ORTHOPEDIC CENTER SUBDIVISION

APPLICATION NUMBER 15 DATE July 24, 2003
APPLICANT Orthopedic Center Subdivision
REQUEST Subdivision

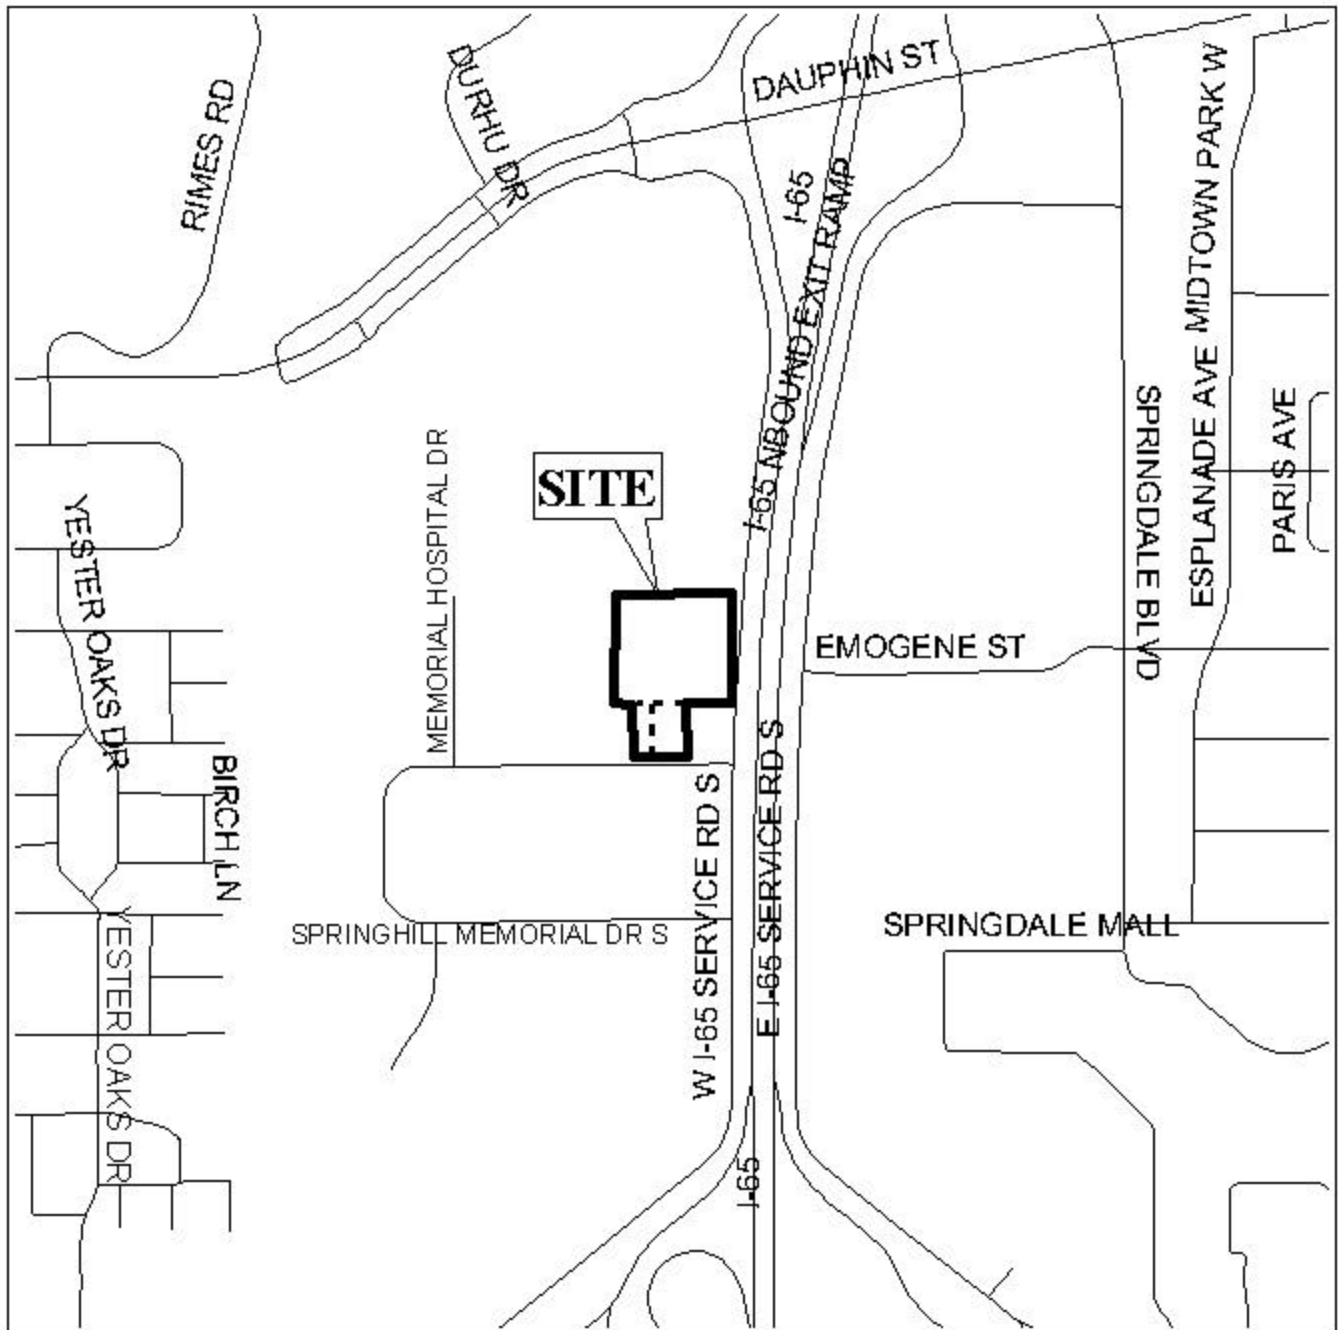
The plat illustrates the proposed 1-lot, 4.0± acre subdivision which is located on the West side of West I-65 Service Road South, 185'± North of Springhill Memorial Drive North, extending to the North side of Springhill Memorial Drive North, 160'± West of West I-65 Service Road South. The site is served by city water and sanitary facilities.

Interstate 65, which is a planned major street, has right-of-way in compliance with the Major Street Plan. As the site fronts West I-65 Service Road South (which is part of I-65), as a means of access management, a note should be placed on the final plat limiting the lot to the existing curb cuts to I-65 Service Road South and allowing two new curb cuts to Springhill Memorial Drive North with the size, location and design to be approved by Traffic Engineering.

The plat meets the minimum requirements of the Subdivision Regulations and is recommended for Tentative Approval subject to the following condition: 1) the placement of a note on the final plat stating that the lot is limited to the existing curb cuts to I-65 Service Road South and limiting access to two new curb cuts to Springhill Memorial Drive North with the size, location and design to be approved by Traffic Engineering.
